HORSHAM DISTRICT COUNCIL CONSULTATION

TO:	Horsham District Council – Planning Dept
LOCATION:	Land North of Horsham Horsham West Sussex
DESCRIPTION:	Reserved matters application (internal access, appearance, landscaping, layout and scale) pursuant to Condition 5 of Outline Planning Permission reference DC/16/1677 for Phase 1 RM Area 4 comprising 82 (C3 Use) residential units, car and cycle parking, new landscaping, drainage, access and internal roads and associated infrastructure.
REFERENCE:	DC/26/0909
RECOMMENDATION:	Modification

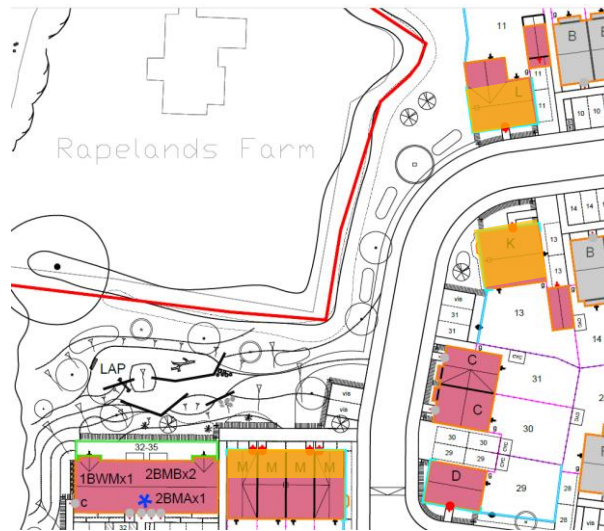
5. Softer treatments are expected to reflect the rural edge character. Please provide a greater proportion of 'natural' colour block paving to the scheme, particularly adjacent to the sensitive landscape buffer and Hollywick (Rapelands) Farm.
6. As above, a greater proportion of tile hanging is expected to be provided adjacent to the sensitive landscape buffer. Please amend the buildings highlighted in orange, below.

7. Further tree lined streets are also expected to reinforce the woodland edge character. Please amend and provide within the streets highlighted in orange, below.

8. Modification is required to enhance amenity for pedestrians, particularly along the central, north-south road above. In addition to tree planting, please amend this road to reflect a wide verge, turfed with flowering lawn.
9. Parking and hardstanding in the area below the sensitive landscape buffer and LAP is deemed excessive in scale and further erodes the rural woodland edge character. A greater provision of trees is required to soften the hardscape.

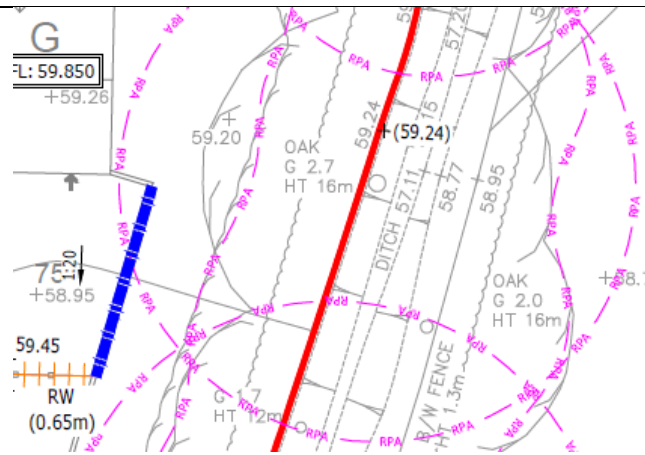
10. The encroachment of the root protection area (RPA) of Oak 18 does not appear within the arboricultural documents under this application or under Condition 16 (DISC/26/0188). While the encroachment appears within the limits to comply with BS 5837:2012, development within RPAs should only be observed where unavoidable. As such, we request the garden boundary and retaining wall of plot 75 to be squared off to avoid the RPA, unless justification can be provided. Oak 18 is noted as being a larger component of the tree-belt and its long term retention is must be demonstrated.

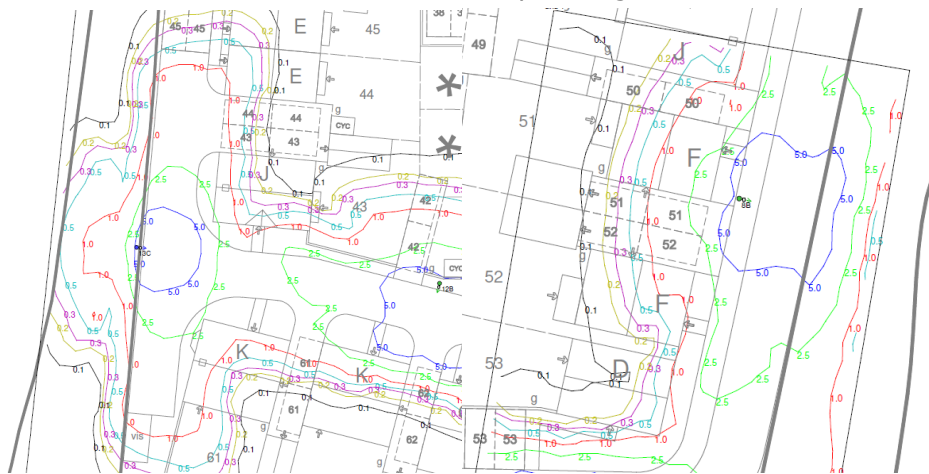
11. While 2700K temperatures are welcomed, the lighting scheme results in a large degree of light spill on sensitive landscape features. Given the limited numbers of dwellings in these areas, in order to minimise disruptive effects on the photoperiodism of the existing tree belt, please consider use of low level bollards or incorporating baffles/deflectors.

[left DISC/26/0188 TPP, middle Drainage Strategy, right Google Maps]

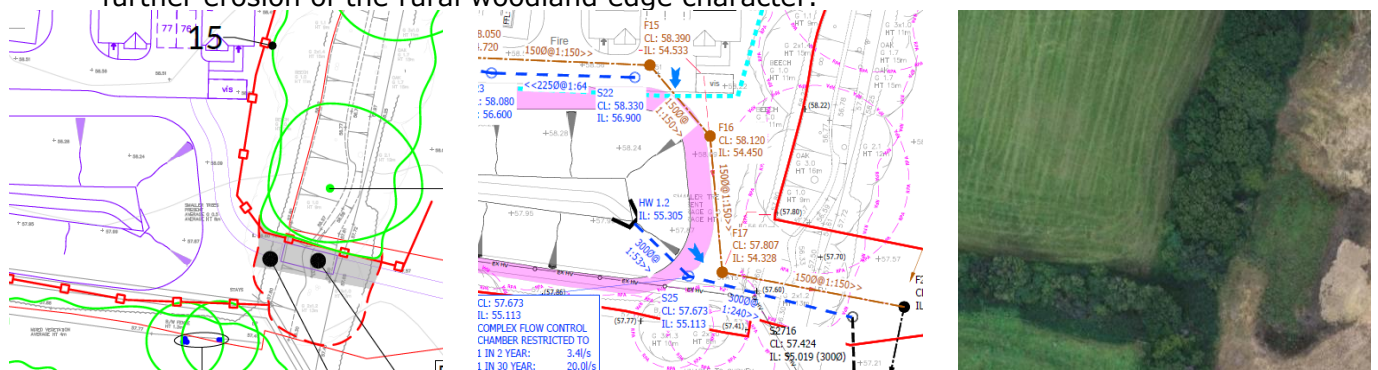
12. The Design Compliance Statement notes that pedestrian access and service trenches will follow the same route in the southeast corner, however two separate routes are proposed. While the Tree Protection Plan (TPP) under DISC/26/0188 has been approved, please consider locating the footpath to follow the same route as services to limit tree removal and thus further erosion of the rural woodland edge character.

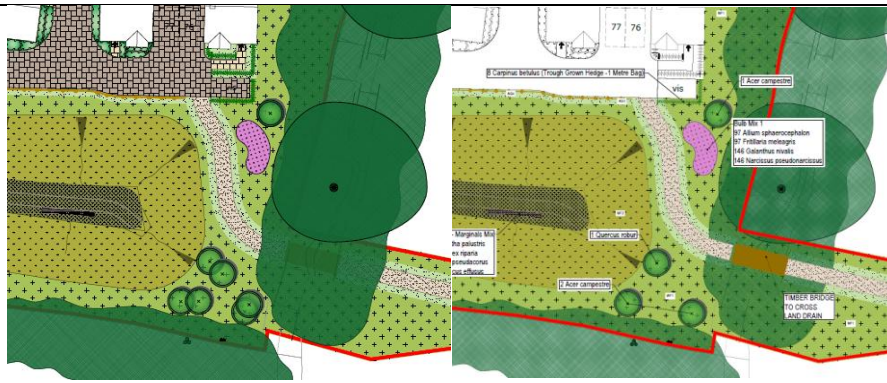
13. Discrepancy between the Landscape Masterplan (below, left) and Soft Landscaping Plans (below, right) notwithstanding, proposed trees must be relocated elsewhere to avoid clashes with proposed services.

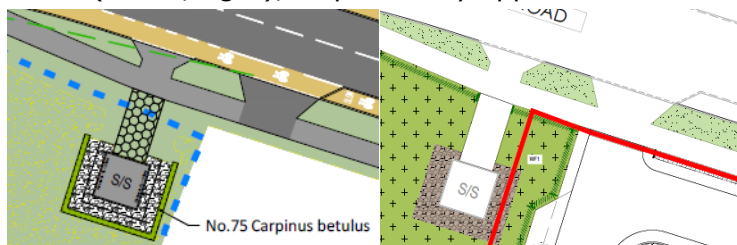
15. In order to comply with Horsham District Council's Open Space, Sports & Recreation Review 2021 (OSSR), provision of a hard-surfaced path is required to access the LAP. Please note that Breedon self-binding gravel, CEDEC gravel, or similar is preferred in this location.
16. As per the OSSR, a minimum buffer of 5m between the boundary of the nearest dwelling and the main activity zone must be demonstrated. As such, the LAP should be extended to create further space and the boulders adjusted further northeast, levels permitting. This will contribute to creating a more attractive, open area of play.
